LEYLAND-TRIUMPH SALES COMPANY, INC.

TO: ALL TRIUMPH DEALERS - WESTERN ZONE

DEPT: SERVICE DEPARTMENT

Exploded view of Solex B.30 P.S.E.I. Carburettor

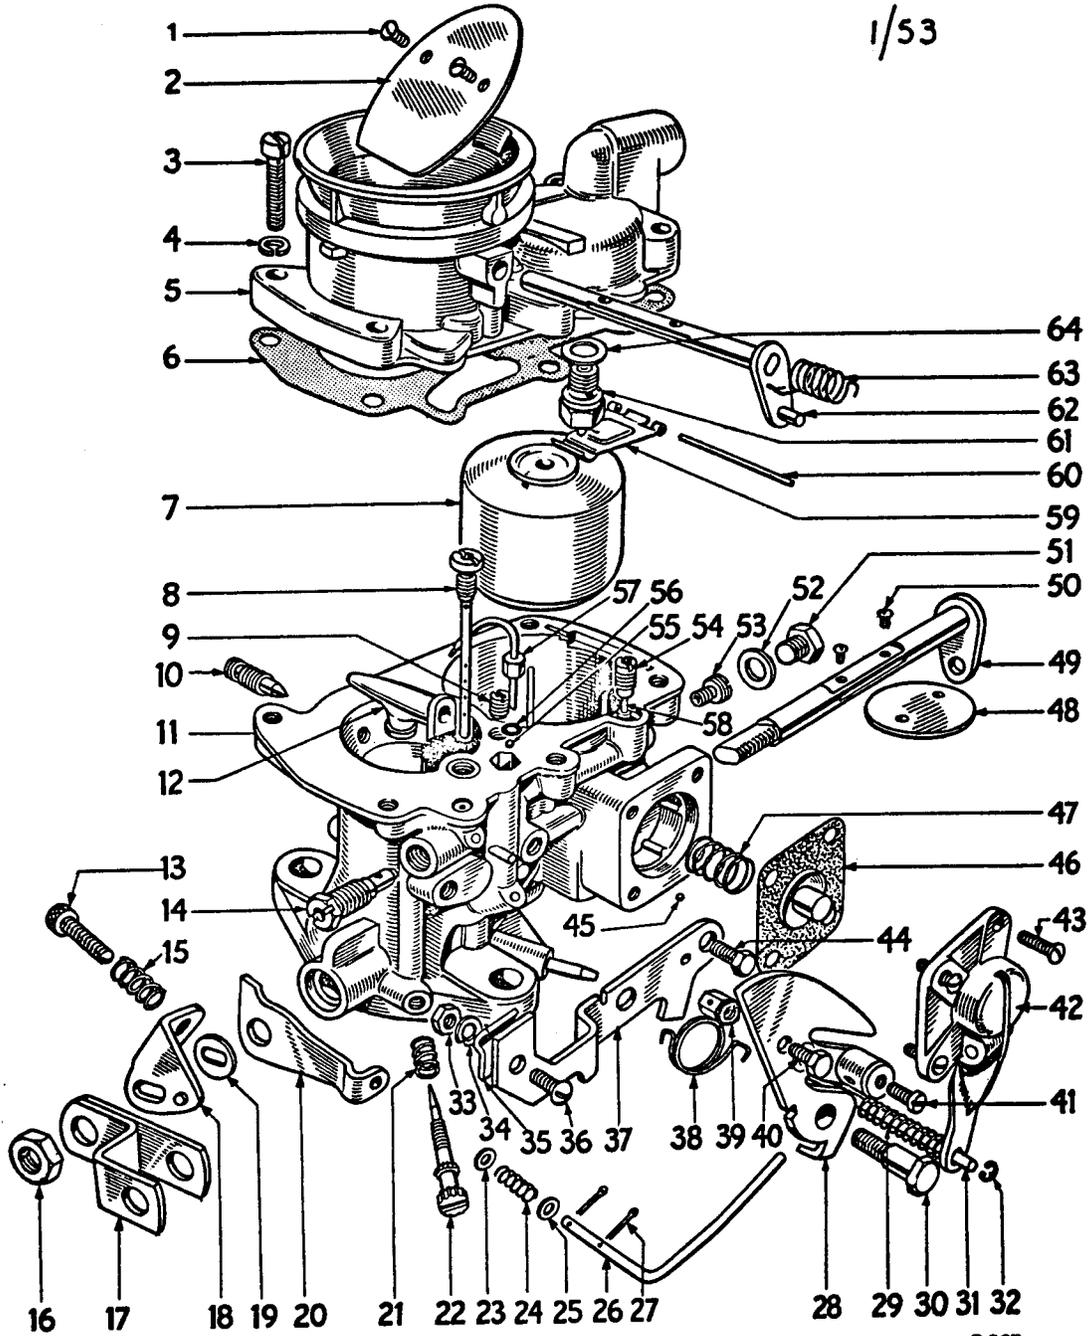
The following instructions are given for the removal of the main jet and the setting of the fast idle on the above type carburetor.

- (a) Remove top cover (5) (5 screws).
- (b) Remove float lever (59) and float (7).
- (c) At this point the accelerator pump jet (57) will loosen and could be knocked into the throat of the carburetor. Therefore, it is advisable to remove it, being careful not to lose the neoprene sealing washer (56) on the underside of the nozzle.
- (d) Remove plug (51) at lower front side of the float chamber and insert screwdriver to remove main jet (53), which is on the inside face of the float chamber.

NOTE: When replacing the top cover (5), the strangler (2) must be held open, otherwise, by the neutral spring action, it will close and then be on the wrong side of the strangler operating cam (28).

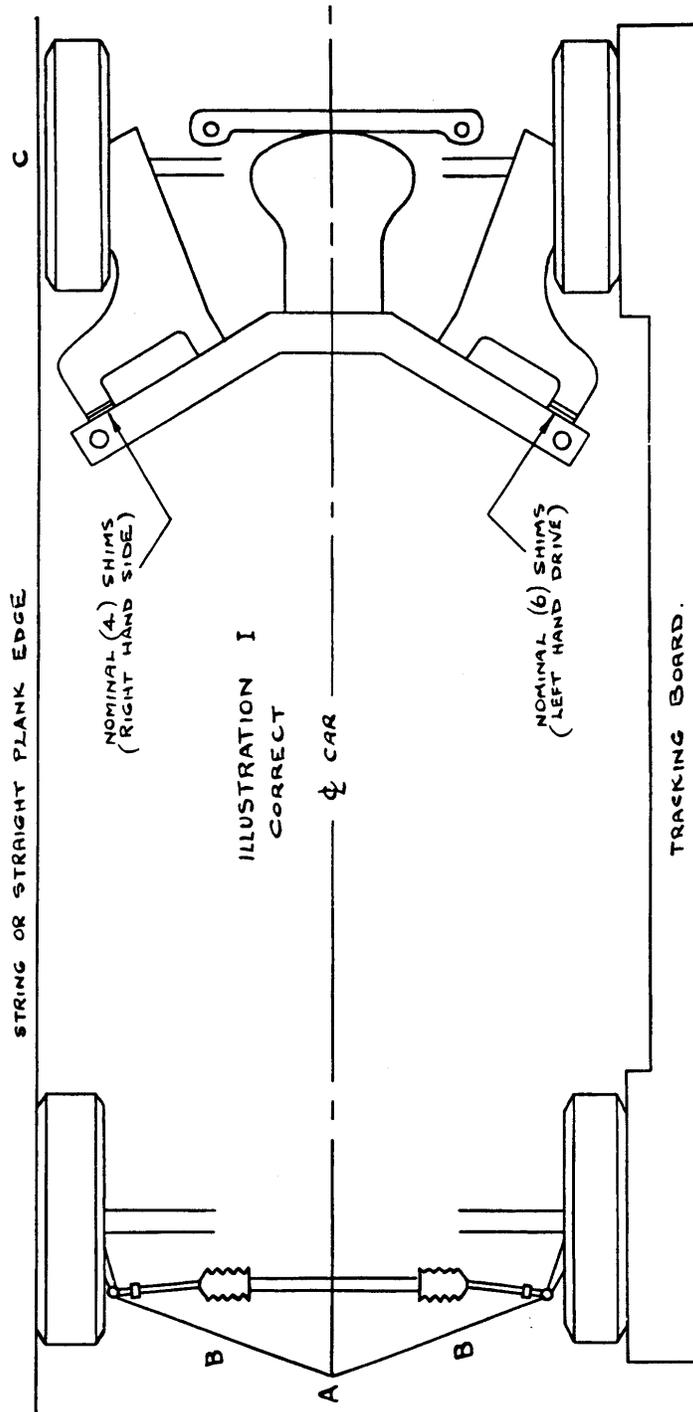
-
4. Apply tracking board, string or straight edge against front tire walls and if the geometry is correct the position shown in illustration 1 will be apparent. (The illustration shows use of tracking board or straight edge.)

ILLUSTRATION 4

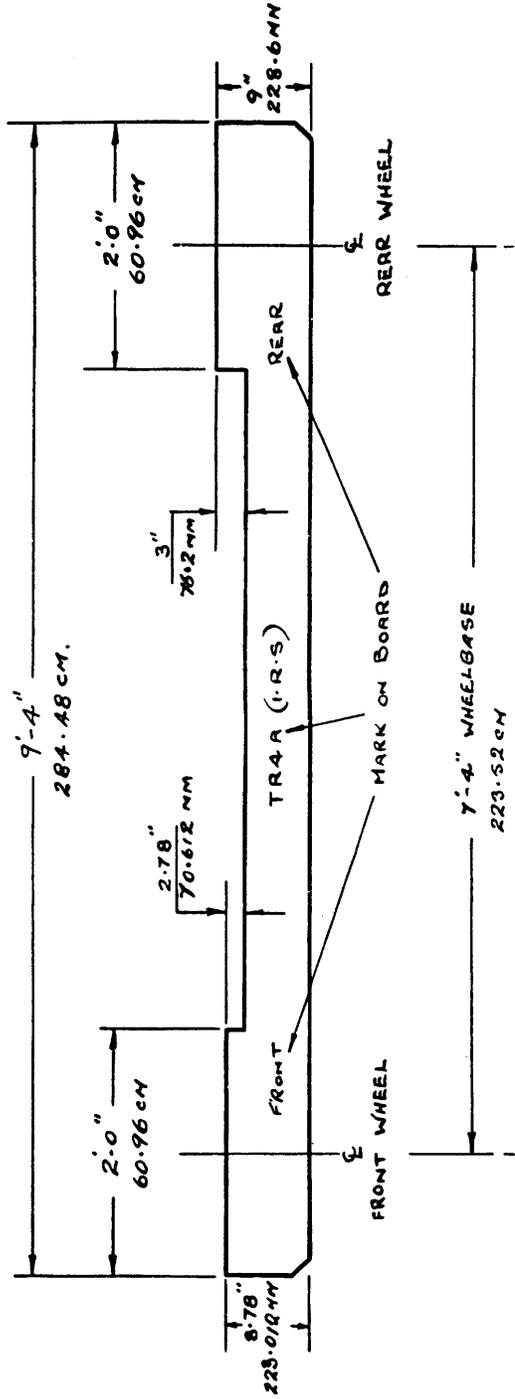
Illustrations, Nos. 4 and 5, detail measurements for making up separate tracking boards for the above models. The two separate boards may be combined if desired by dimensioning both straight edges of one board, i.e., back to back.
